2 REVISIONS TO THE DRAFT EIR

2.1 REVISIONS TO THE DRAFT EIR

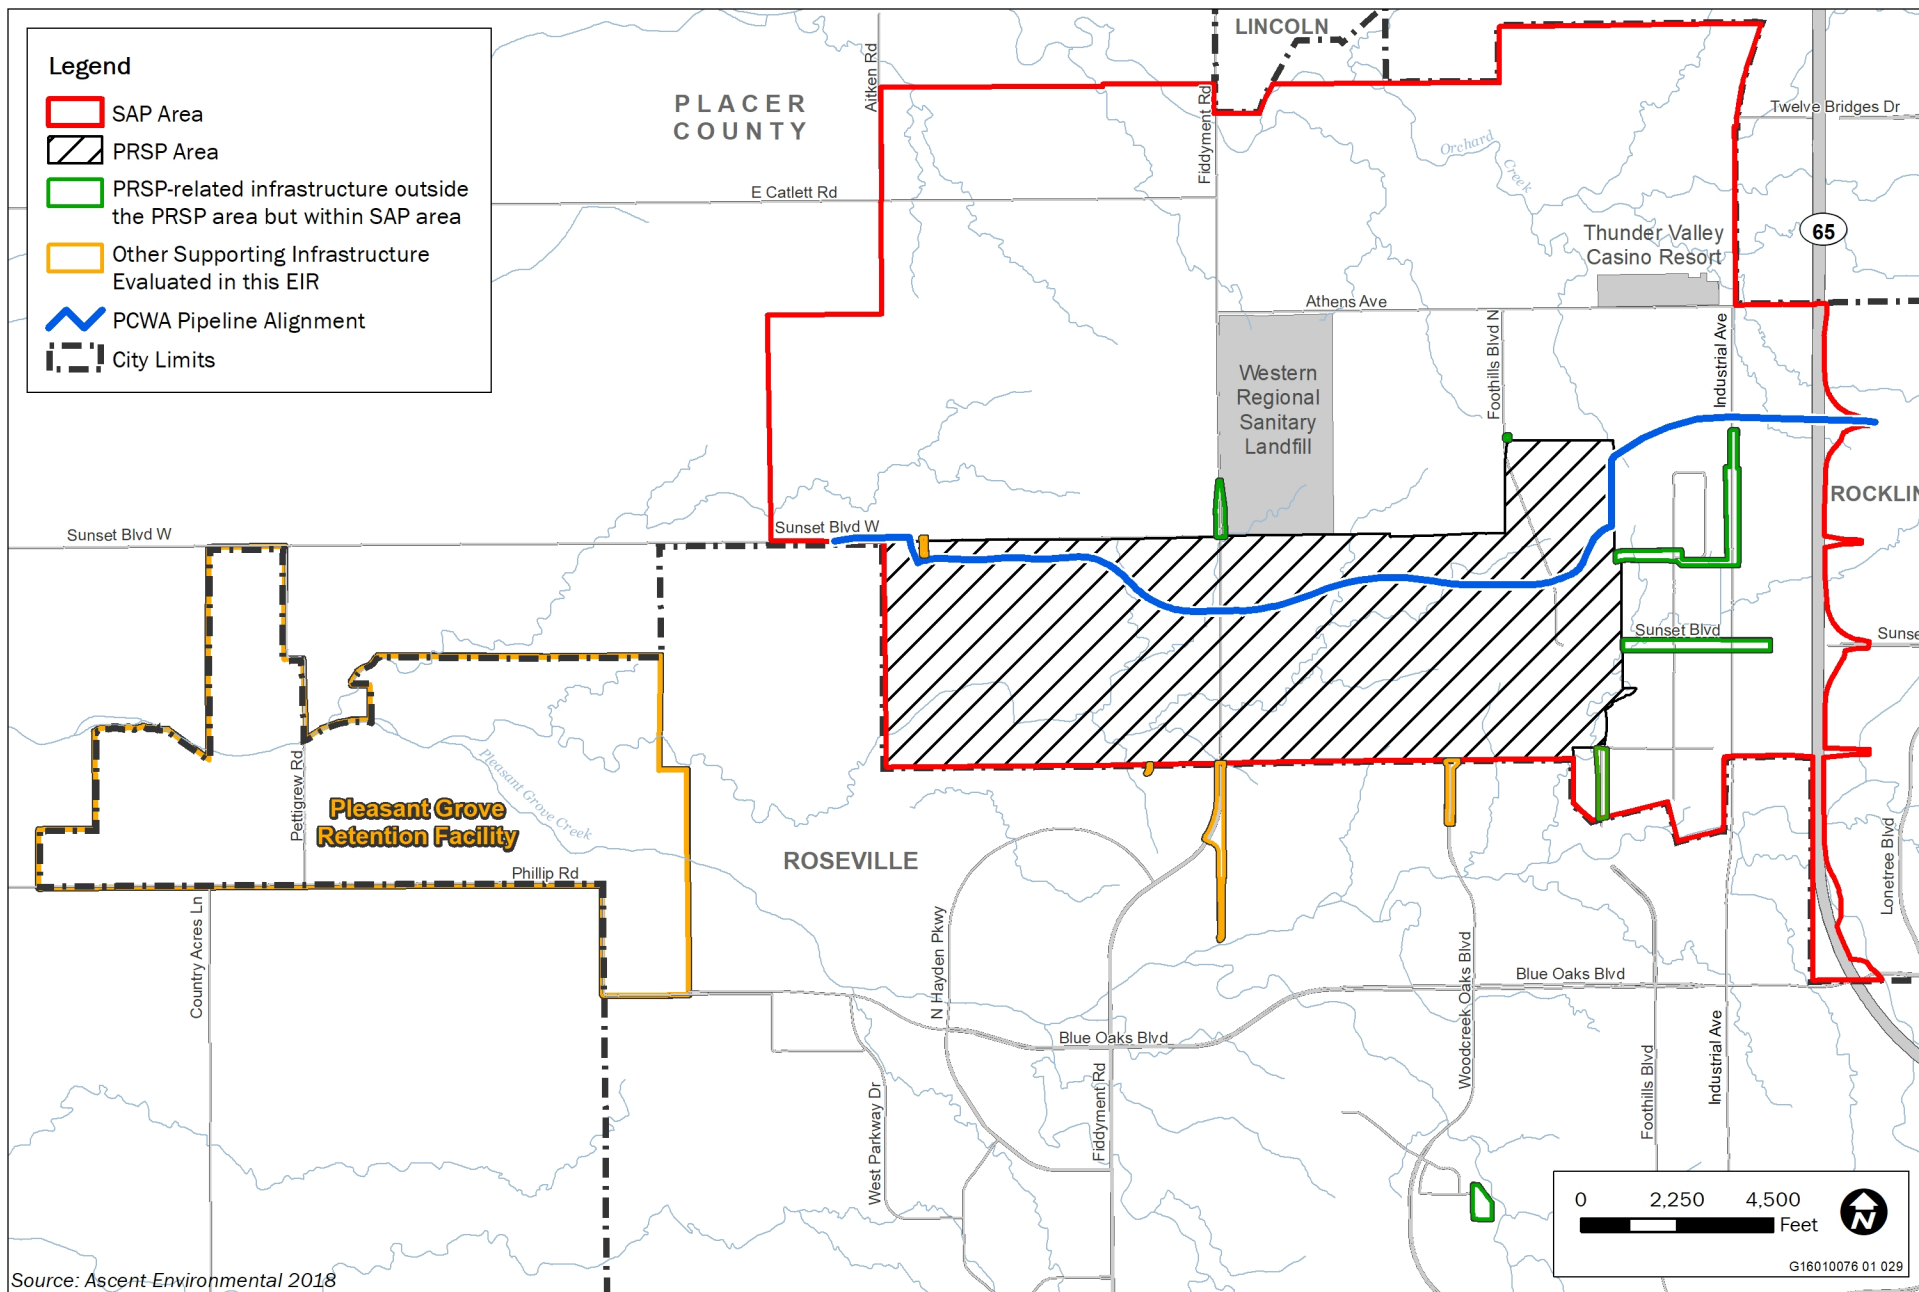
In response to comment 4-24 and to provide an updated exhibit that reflects the annexation of the Amoruso Ranch Specific Plan into the City of Roseville boundaries, which was approved by the Placer County Local Agency Formation Commission in December 2018, as well as to correct the PCWA pipeline alignment within the PRSP area, Exhibit 3-3 on page 3-4 of the Draft EIR is revised as follows: [see following page]

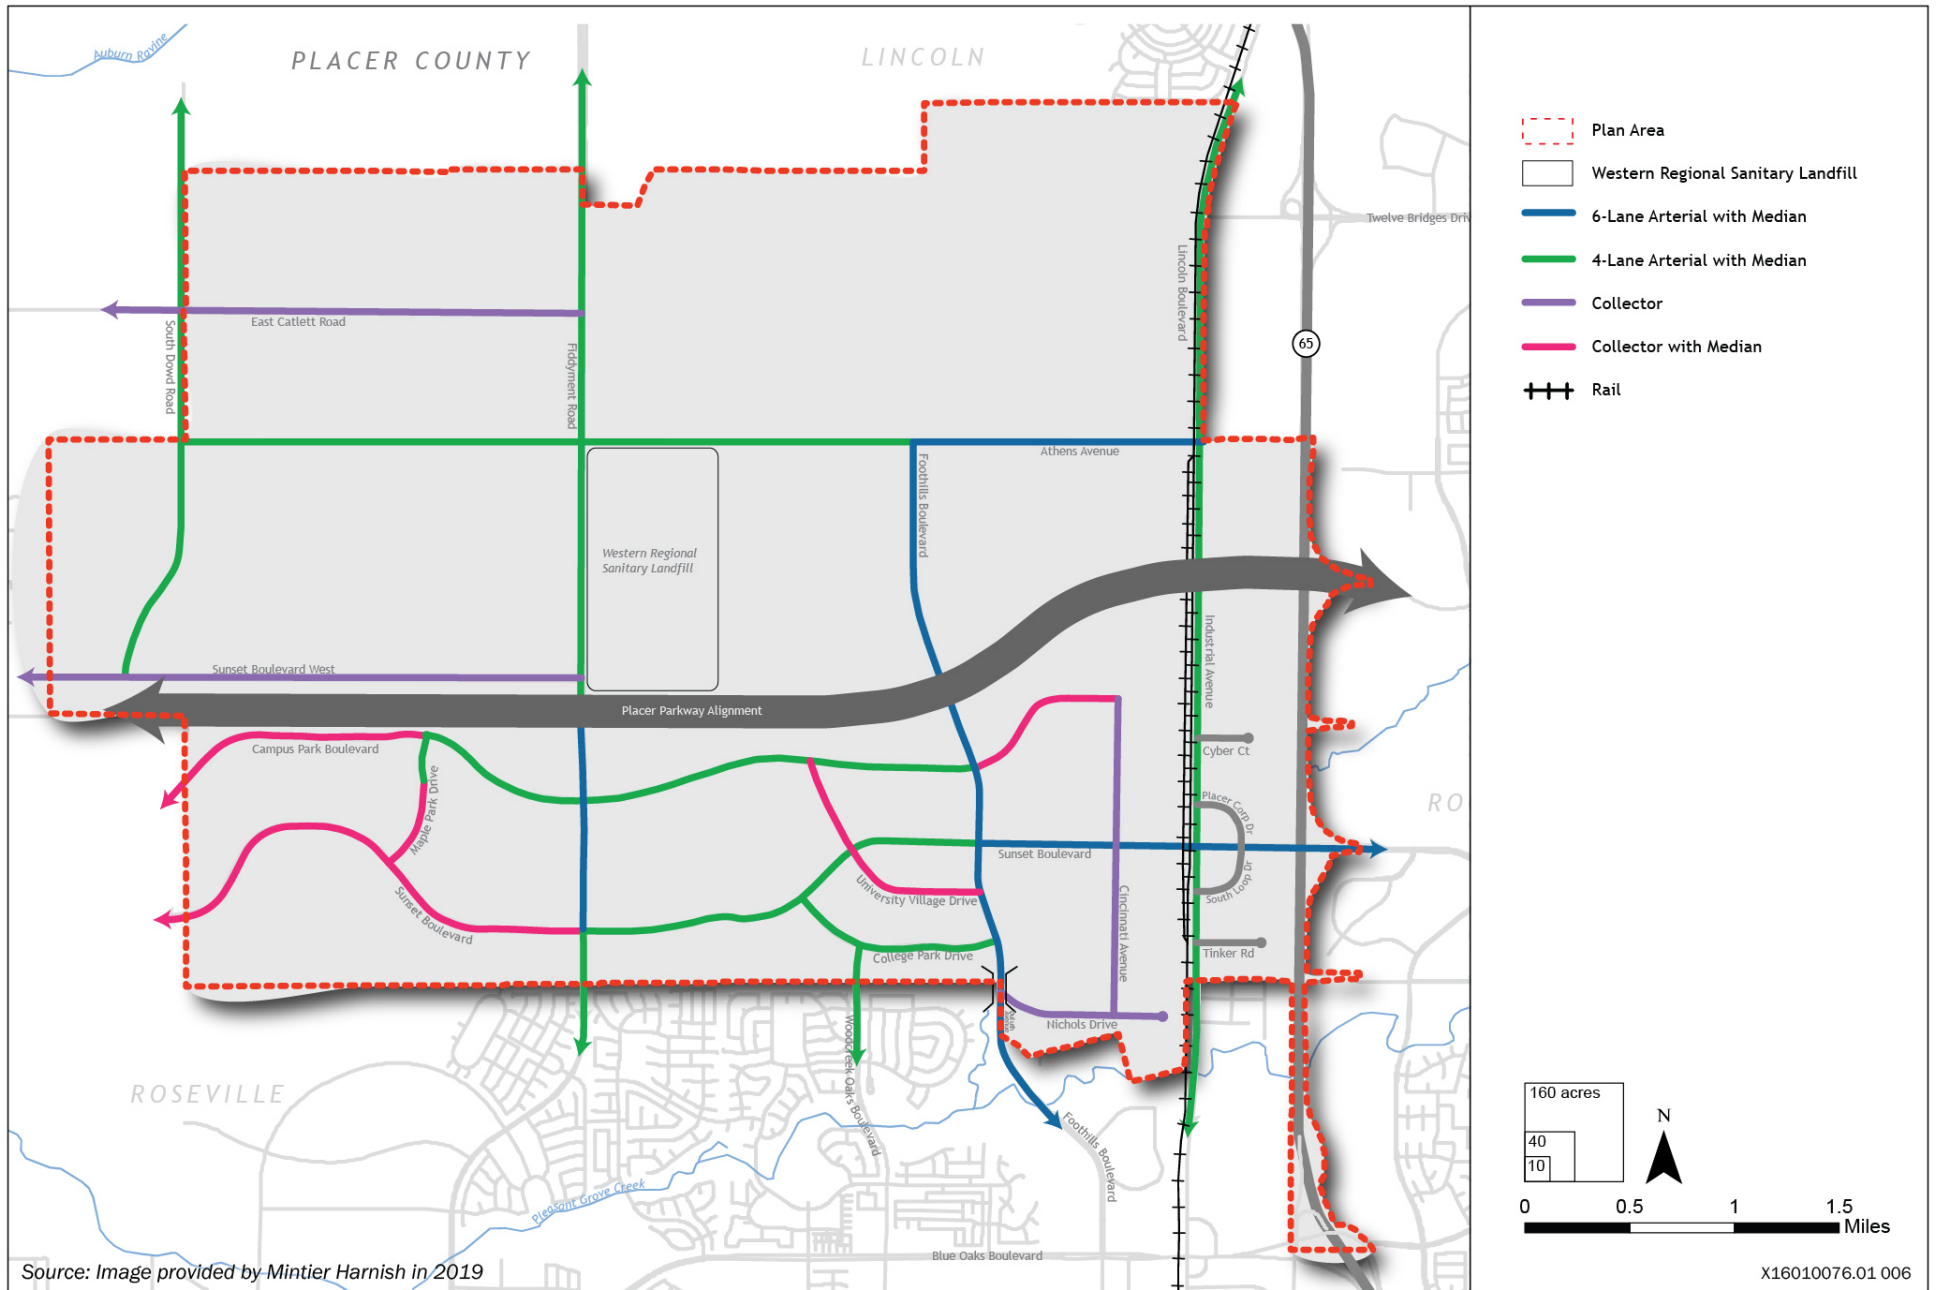
To provide a revised circulation diagram for the Sunset Area Plan that reflects the following changes (1) changed University Village Drive in Placer Ranch to be a Collector with Median and (2) added label for Duluth Avenue to show it as the connection between Foothills Boulevard in the Sunset Area and Foothills Boulevard in Roseville, Exhibit 3-7 on page 3-23 of the Draft EIR is revised as follows: [see following page]

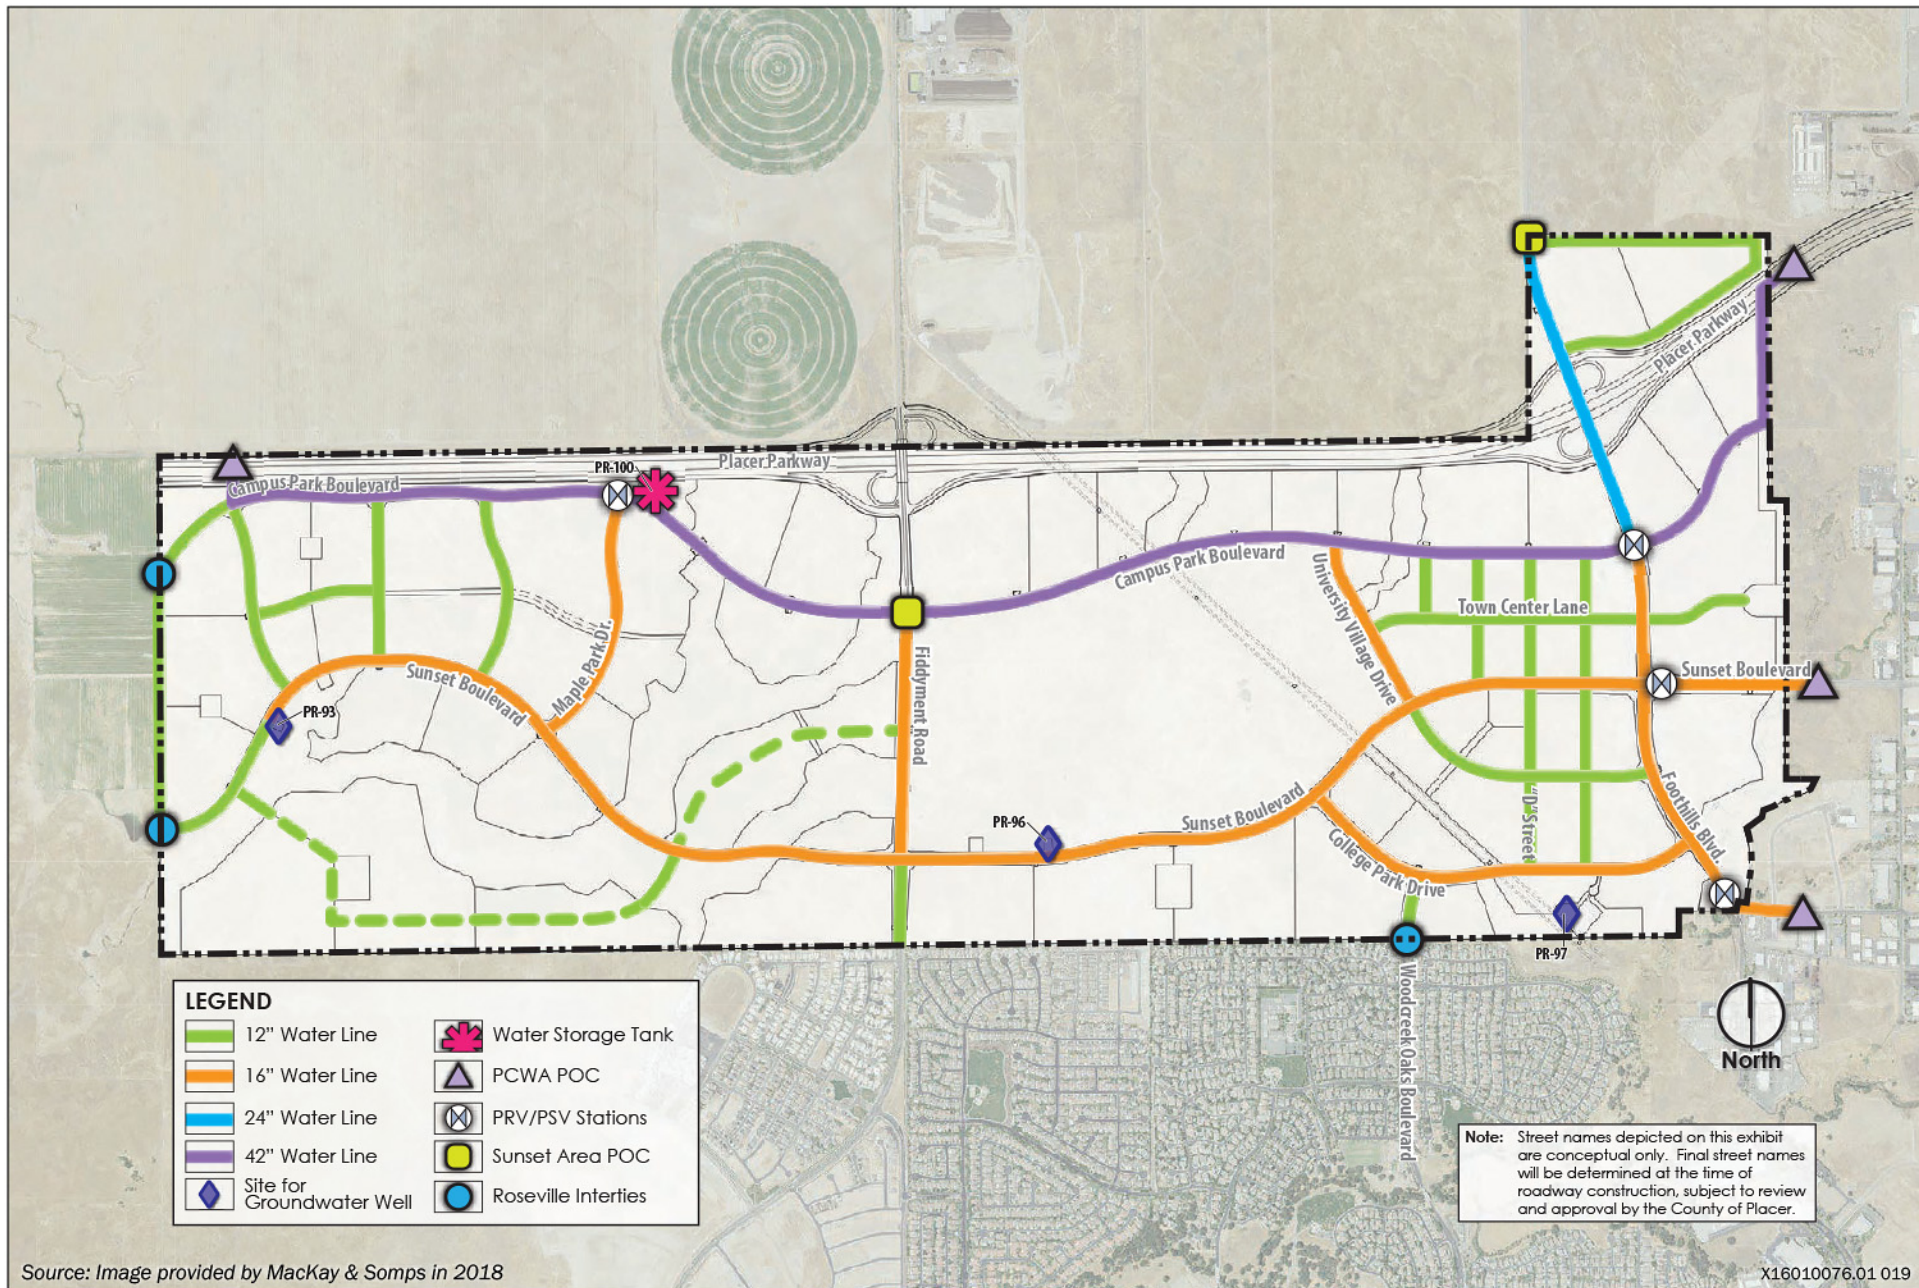
In response to comment 7-3 and to provide an updated exhibit that shows the Sunset Area Point of Connection (POC) at the west area and to relabel all PCWA connections as POCs, not interties, Exhibit 3-19 on page 3-52 of the Draft EIR is revised as follows: [see following page]

Exhibit 3-27

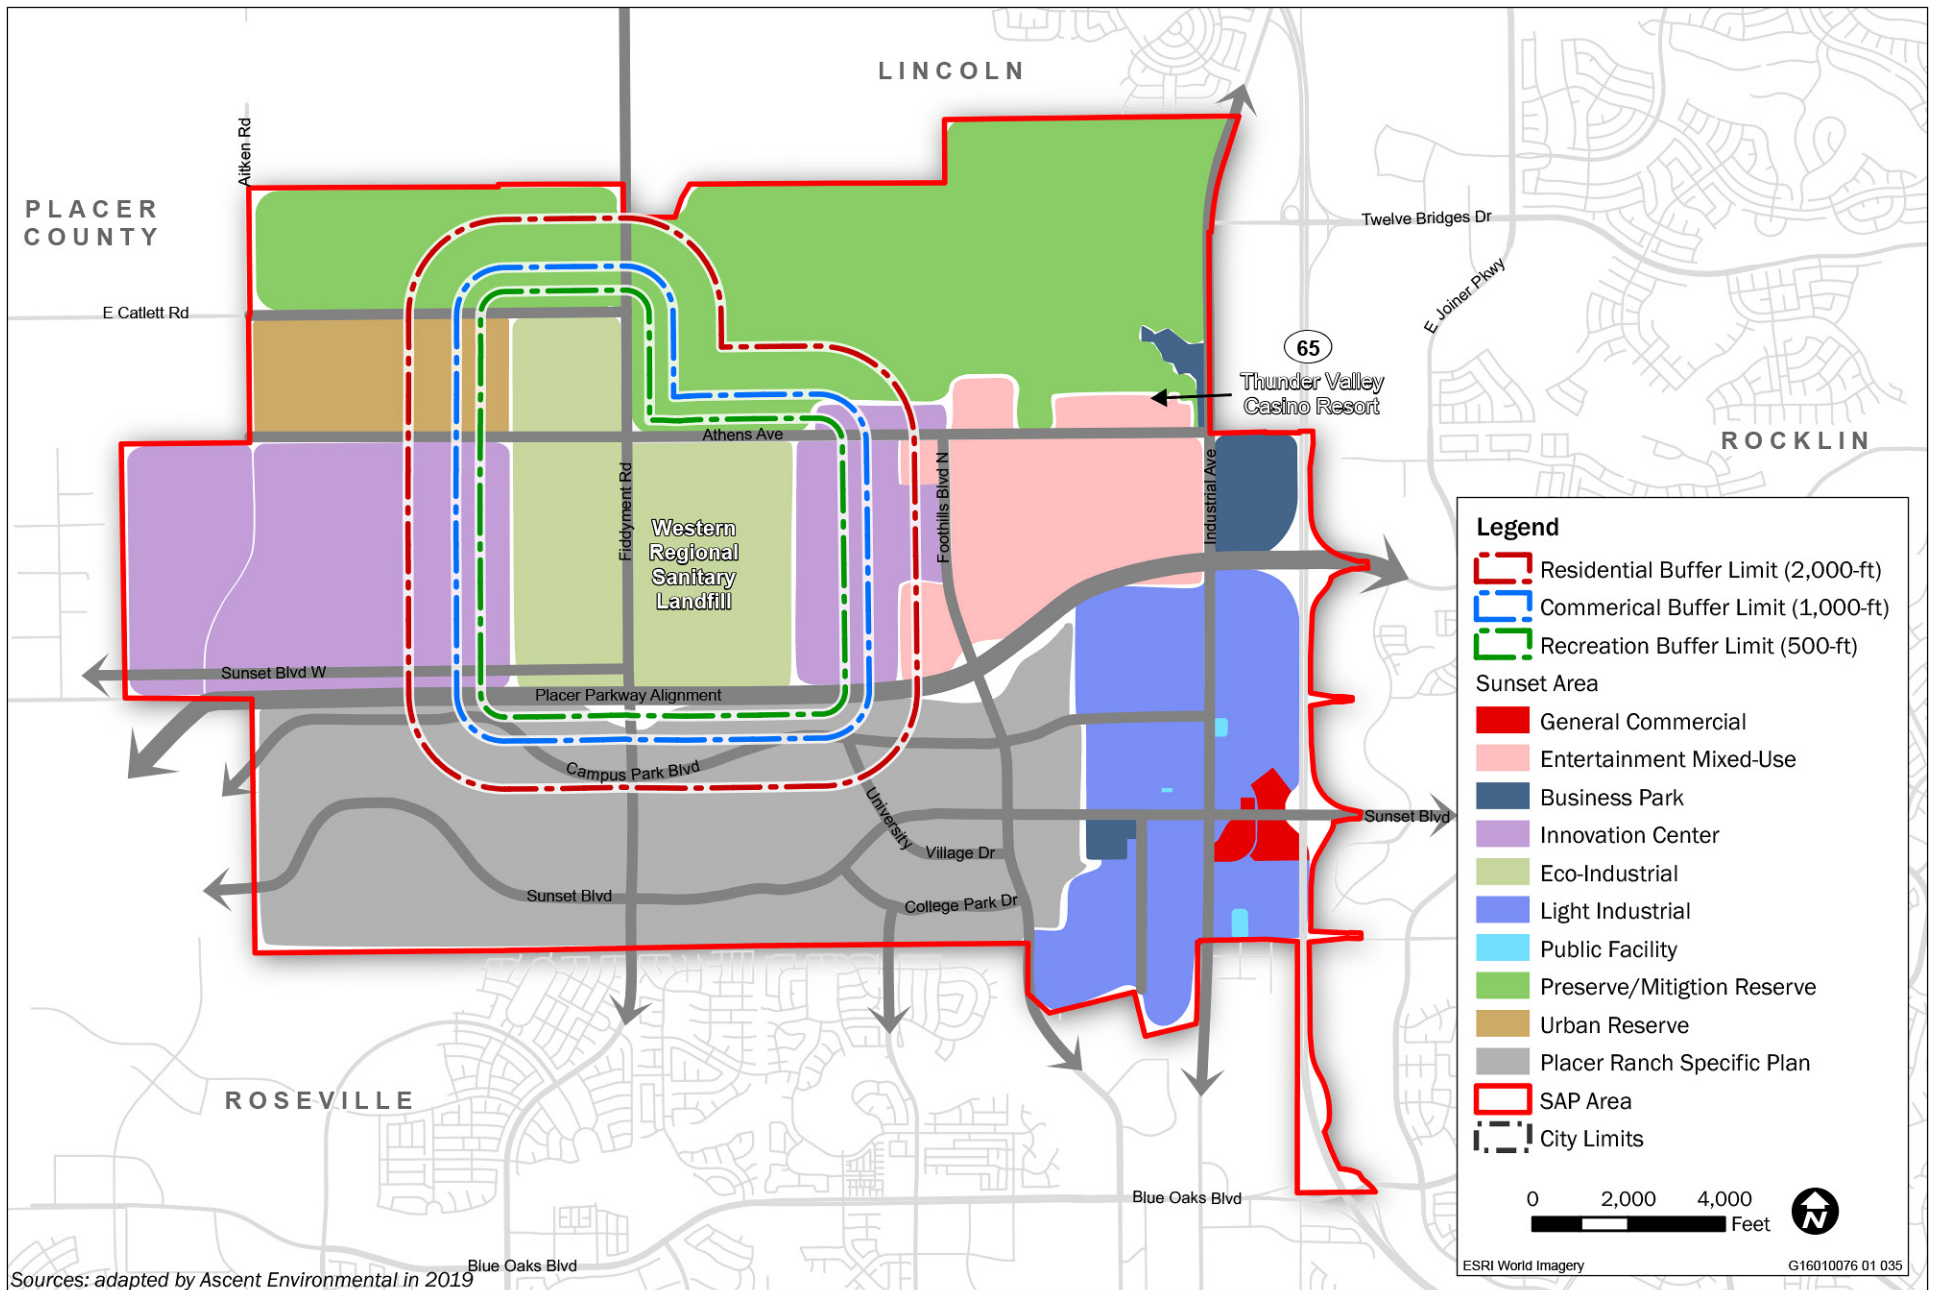
In response to comment 31-13 and to show the location of the SAP proposed sanitary landfill buffers, the first sentence on page 3-74 of the Draft EIR has been revised as follows: [see following page]

The County has revised the proposed amendment to the General Plan landfill buffer policy to eliminate the newly proposed allowance of residential uses within 1,000 feet of the landfill with approval of a specific plan, master plan, or development agreement and replace it with a requirement that all new residential development proposed between 1 mile and 2,000 feet of any solid waste disposal site property boundaries requires approval of a specific plan, master plan, or development agreement. The following revision is therefore made to note 5 at the bottom of Table 1-5 [from the County General Plan] as shown on page 3-74 of the Draft EIR:
